SPS THREE SCHOOL RE-ROOFS, SUFFOLK, VA

Oakland Elementary School Mack Benn Jr. Elementary School Northern Shores Elementary School

Addendum Two February 23, 2022

AREA NAME: GYMNASIUM ROOF RETROFIT

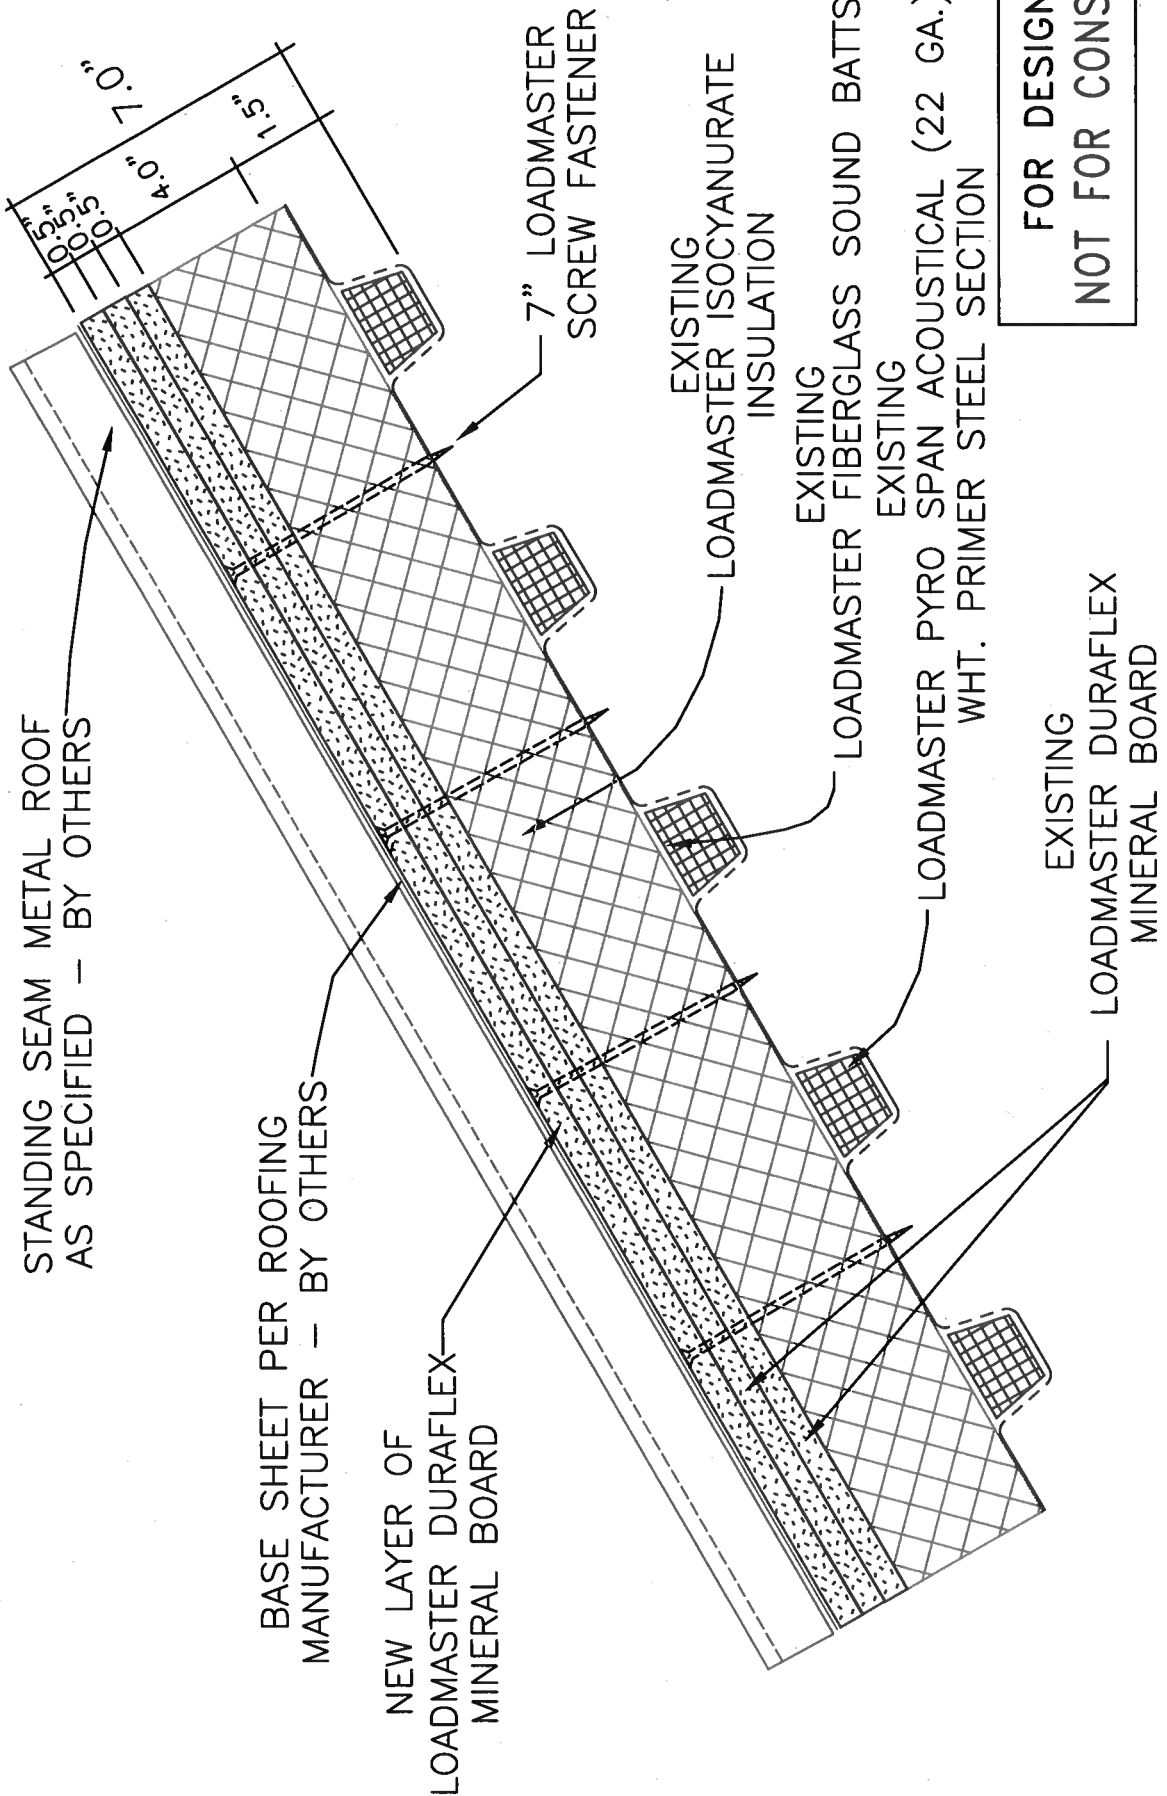
- The existing roof deck on the gymnasium roof areas of Oakland Elementary School and Mack Benn Jr. Elementary School have been determined to be Loadmaster Engineered Assemblies. Therefore, the new roof system composition for these specific roof areas on each school is changed to meet the requirements of the attached Loadmaster Retrofit CompuDesign roof assemblies.

The new roof system composition for the gymnasium roof areas shall be as follows:

- New Standing Seam Metal Roof Panels as per Project Specifications
- New High Temperature Underlayment as per Project Specifications
- New Layer of 1/2-Inch DuraFlex Mineral Board Mechanically Attached Per Loadmaster Requirements
- Existing Double Layer 1/2-Inch DuraFlex Mineral Board (replace wet or damaged as required)
- Existing Loadmaster 4-Inch Isocyanurate Insulation (replace wet or damaged as required)
- Existing Loadmaster Fiberglass Sound Batts (replace wet or damaged as required)
- Existing Pyro Span Acoustical 22 Gauge Steel Roof Deck (replace wet or damaged as required)

2. **Loadmaster Retrofit Roof Assembly:** After completing the demolition of the existing shingle roof and underlayment down to the existing Loadmaster Duraflex Boards and the necessary repairs to the existing Loadmaster roof deck assembly, add one (1) layer of ½" Loadmaster Duraflex Mineral boards on top of existing Duraflex Board using special screw fasteners and compression devices, which will be assembled on the jobsite in accordance with the project plans, specifications, and Loadmaster recommendations. Any new/replacement steel deck sections shall be Pyro Span 22 gauge and will be secured to the steel structure with #12 joist screws and #12 sidelap screws.
